PERMIT # 232137

SEPTIC IMPROVEMENT PERMIT / AUTHORIZATION TO CONSTRUCT / OPERATION PERMIT / EXISTING SYSTEM

185 MIDWAY LAKE RD, MOORESVILLE. LOT 1

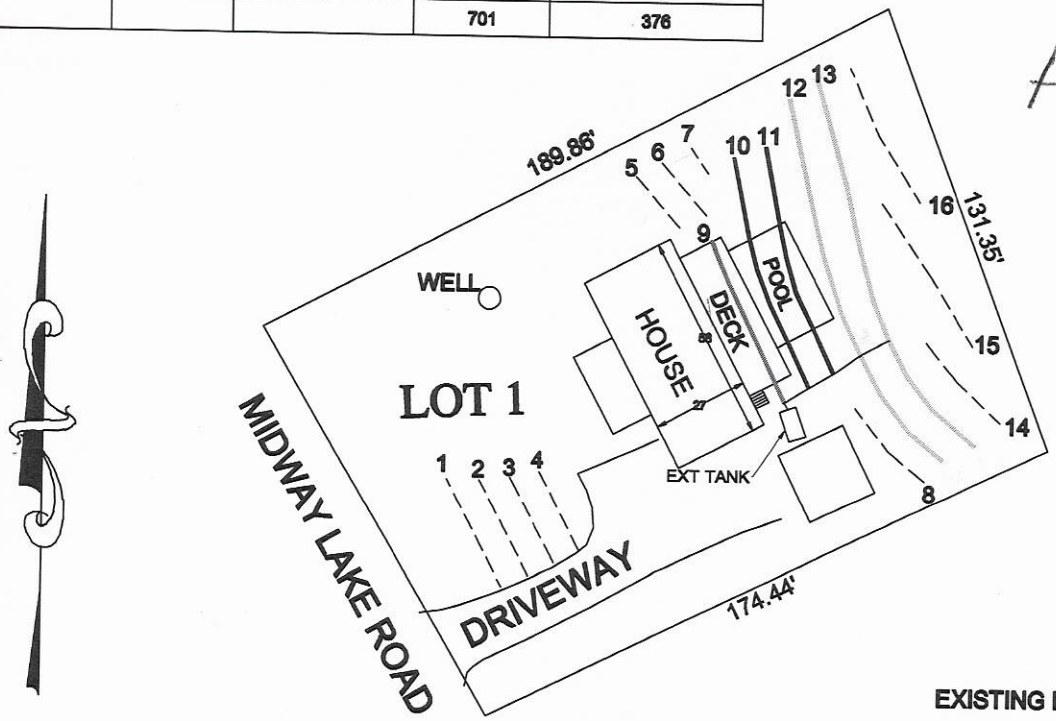
Comments / Conditions: Note: Aboveground swimming pool must be removed. Deck cannot extend greater than 16ft from home to maintain 5ft setback from drainfield.

* Only 200ft of additional drainfield required.

only 200

NOTES: BEFORE INSTALLATION REMOVE POOL
-DISCONNECT FROM LINE 9 AND SERIAL DISTRIBUTE THEN CENTER FEED LINES 12 AND 13
-REPLACE OR MOVE FLUSH VALVES AT THE END OF EACH LINE
-THE DECK MUST BE 10' DEEP TO MAINTAIN 5' FROM LINE 10
